Inspection / Replacement of Teeter Stops

Inspect the height of the teeter stop and replace, if necessary.

Manufacturer Bulletin 01/2012

Measuring the height of the teeter stop

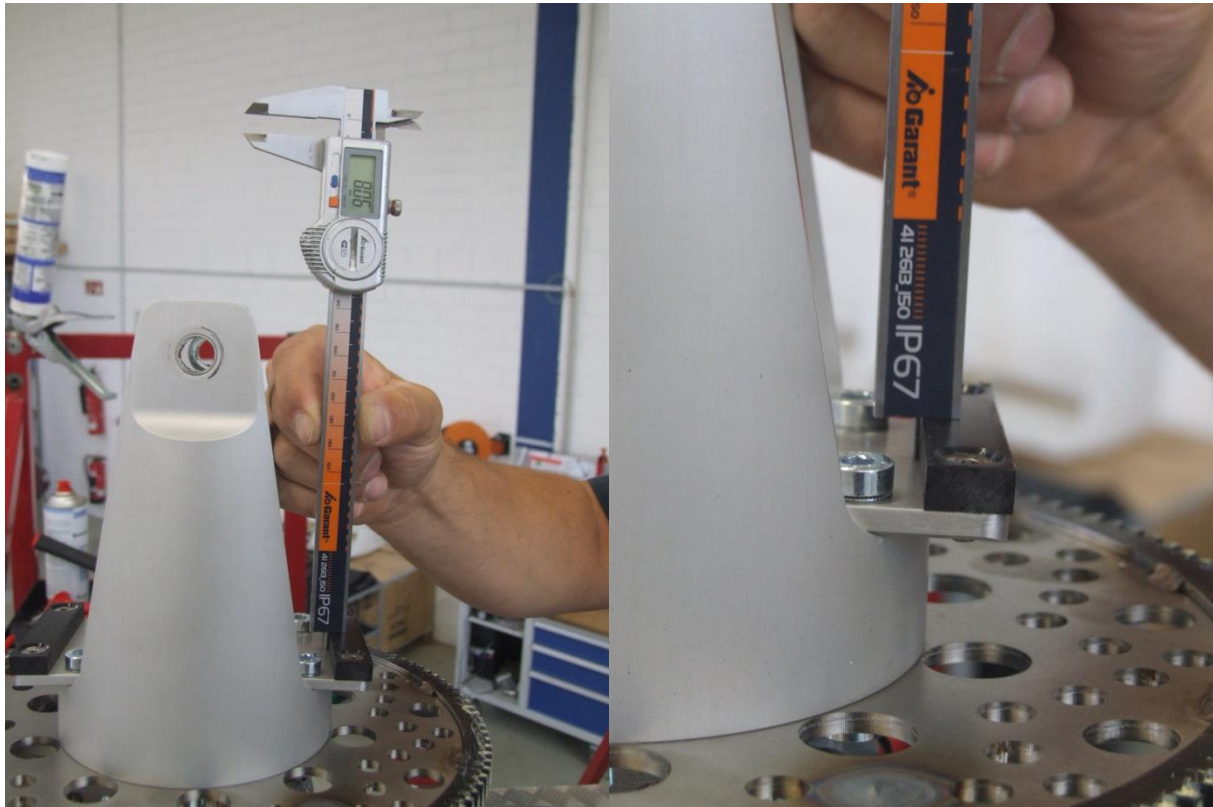
Measure height of teeter stops with a calliper. If height complies with the nominal dimension of 7 +/- 0.2 mm no further action is required.

In case of deviation the teeter stops have to be replaced as instructed below.

(Measurement shows an out-of-tolerance teeter stop)

1. Remove rotor system acc. to POH 8.15.1 or Maintenance Manual
2. Remove teeter stops
3. Position new teeter stops, apply LOCTITE 243 to the threads of the attachment bolts and torque with 6 Nm.
4. Install rotor system acc. to POH 8.15.4 or Maintenance Manual
